DEVELOPMENT REVIEW COMMITTEE (DRC) COMMENT REPORT

PROJECT NAME: 201

CASE NUMBER: UDP-S22019

REQUEST: Site Plan Level IV Review: Request for Reduced Setbacks and to Exceed Maximum Building Length for a 233-Room Hotel in the Central Beach Regional Activity Center

1 Building Corner/Building Material

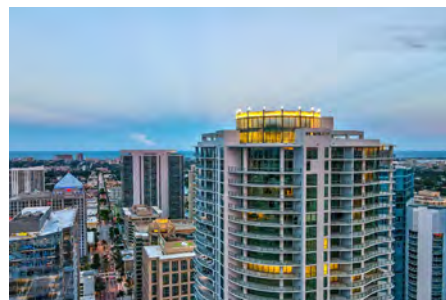
- a. Provide a stronger building presence at the corner of A1A and Poinsettia Street;
 - b. Increase the pedestrian space at the corner of A1A and Poinsettia Street by shifting the storefront back from the property line;

- c. Provide for high quality building materials facing the public realm;
 - d. Exceptional architectural parking podium screening;
 - e. Double story height for the first level at a minimum of 21 feet floor to ceiling height;

- f. Remove the existing structures entirely from the design;
 - g. Enhance the tower top design by adding additional treatment and composition for uniqueness;
